# **Mobile Intel<sup>®</sup> Pentium<sup>®</sup> II Processor Specification Update**

Release Date: January 2006

Order Number: 243887-050

Figure 1. TAP Gageable Thread Clarification

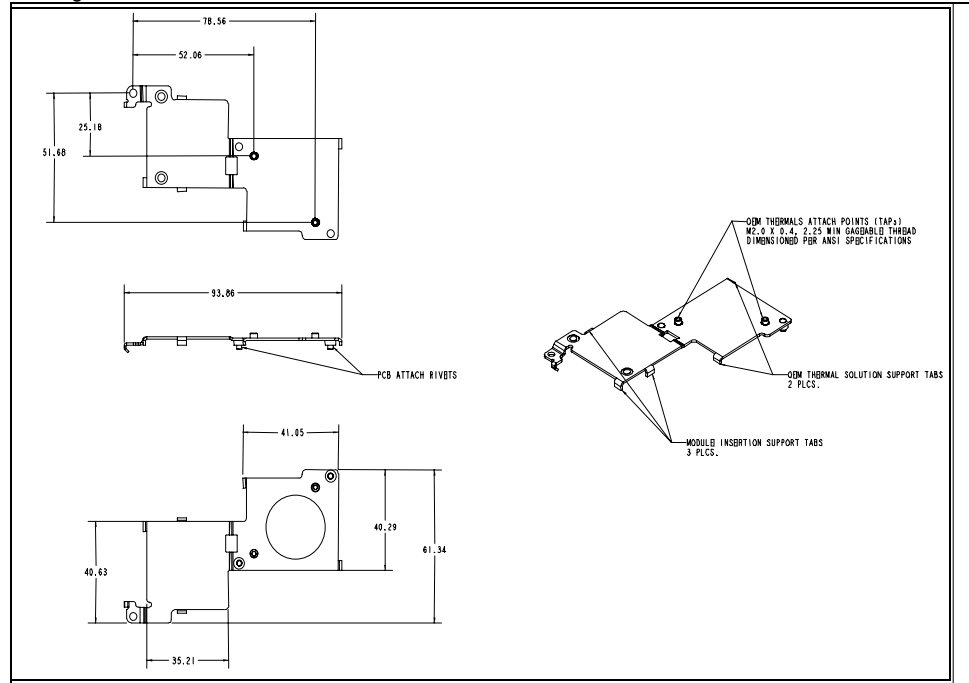
In the *Intel® Pentium® II Processor Mobile Module : Mobile Module Connector 1 (MMC-1)* and the *Intel® Pentium® II Processor Mobile Module : Mobile Module Connector 2 (MMC-2)* datasheets (Order Numbers 243667 and 243668, respectively), the thermal attach point (TAP) gageable thread specification was not clearly identified in Figure 14, of Section 5.2. The following is the TAP clarification:

OEM Thermal Attach Points (TAPs) M2.0 x 0.4, 2.25 min gageable thread dimensioned per ANSI specification.

See Figure 1 below for more information.
